**TOWN OF HICKORY CREEK, TEXAS
ORDINANCE NO. 2012 -08-688**

AN ORDINANCE OF THE TOWN OF HICKORY CREEK, TEXAS, AMENDED THE CODE OF ORDINANCES OF THE TOWN OF HICKORY CREEK, TEXAS, CHAPTER 3, BUILDING REGULATIONS, BY ADOPTING THE INTERNATIONAL BUILDING CODE, 2009 EDITION THAT ARE NOT IN CONFLICT WITH THE INTERNATIONAL RESIDENTIAL CODE; ADOPTING LOCAL AMENDMENTS TO THE INTERNATIONAL BUILDING CODE AS RECOMMENDED BY THE NORTH CENTRAL TEXAS COUNCIL OF GOVERNMENTS; ADOPTING THE INTERNATIONAL RESIDENTIAL CODE, 2009 EDITION, REGULATING THE DESIGN, CONSTRUCTION, QUALITY OF MATERIALS, ERECTION, INSTALLATION, ALTERATION, REPAIR, LOCATION, RELOCATION, REPLACEMENT, ADDITION TO, USE OR MAINTENANCE OF ONE- AND TWO-FAMILY DWELLINGS AND TOWNHOUSES NOT MORE THAN THREE STORIES IN HEIGHT; ADOPTING LOCAL AMENDMENTS TO THE INTERNATIONAL RESIDENTIAL CODE AS RECOMMENDED BY THE NORTH CENTRAL TEXAS COUNCIL OF GOVERNMENTS; ADOPTING THE INTERNATIONAL MECHANICAL CODE, 2009 EDITION; ADOPTING LOCAL AMENDMENTS TO THE INTERNATIONAL MECHANICAL CODE AS RECOMMENDED BY THE NORTH CENTRAL TEXAS COUNCIL OF GOVERNMENTS; ADOPTING THE INTERNATIONAL PLUMBING CODE, 2009 EDITION; ADOPTING LOCAL AMENDMENTS TO THE INTERNATIONAL P

FIGURE R602.6.1
TOP PLATE FRAMING TO ACCOMMODATE PIPING

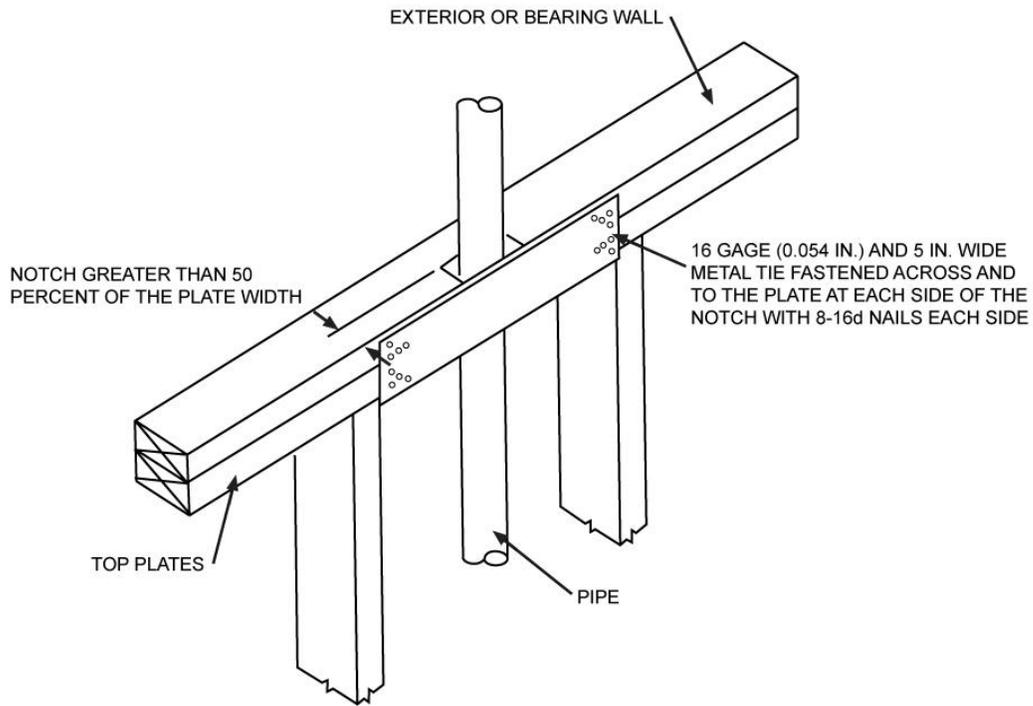
*****Figure R602.6.1; delete the figure and insert the following figure:**

R602.6.1 Drilling and notching of top plate. When piping or ductwork is placed in or partly in an exterior wall or interior load-bearing wall, necessitating cutting, drilling or notching of the top plate by more than 50 percent of its width, a galvanized metal tie not less than 0.054 inch thick (1.37 mm) (16 Ga) and ~~4 1/2 inches (38) mm~~ 5 inches (127 mm) wide shall be fastened across and to the plate at each side of the opening with not less than eight 10d (0.148 inch diameter) having a minimum length of 1 1/2 inches (38 mm) at each side or equivalent. Fasteners will be offset to prevent splitting of the top plate material. The metal tie must extend a minimum of 6 inches past the opening. See figure R602.6.1.
